ISO/IEC JTC1/SC2/WG2 N3747
ISO/IEC JTC1/SC2/WG2/IRG N1651
Doc. #: Korea JTC1/SC2 K1847_1

Author: KIM, Kyongsok (GIM, Gyeongseog), Chairperson of Korea JTC1/SC2
Date: 2010.01.25
Status: National Body Position, Rep. of KOREA
Subject: A solution proposed by R.O.Korea for incorrectly mapped comptb. chars
(RE: T19 and T20)

71-70 0x6766 (=E7E6)
예 (ye)

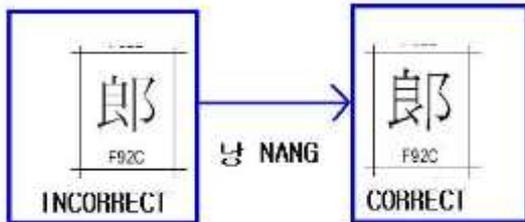
a) By checking the glyphs in 2ed CD, we can see that UF9B8 should be mapped to U96B7, not to U96B8.

- Therefore, any compatibility Hanja characters (whose source is K0, including UF9B8) must be mapped to a K0 Hanja (in this case, U96B7), but not to K1 Hanja (in this case, U96B8).

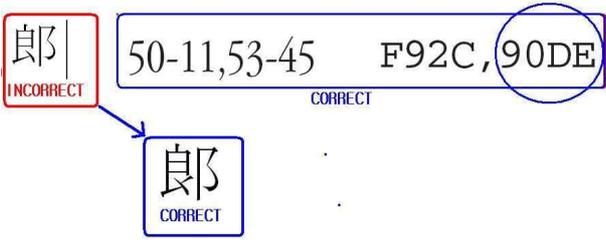
c) If the glyph of U+F92C (0x522B, 50-11, 냥 Nang) WERE correct (10 strokes),
 - since the glyph of U+F92C (0x522B) is different from the glyph of 랑 Rang (0x554D, 53-45, 11 strokes), U+F92C (0x522B) SHOULD NOT HAVE BEEN encoded as compatibility Hanja.

- Therefore, we can conclude that the glyphs of "냥 Nang (0x522B, 50-11)" and "랑 Rang (0x554D, 53-45)" in KS C 5601 are exactly the same and the number of their strokes is 11.
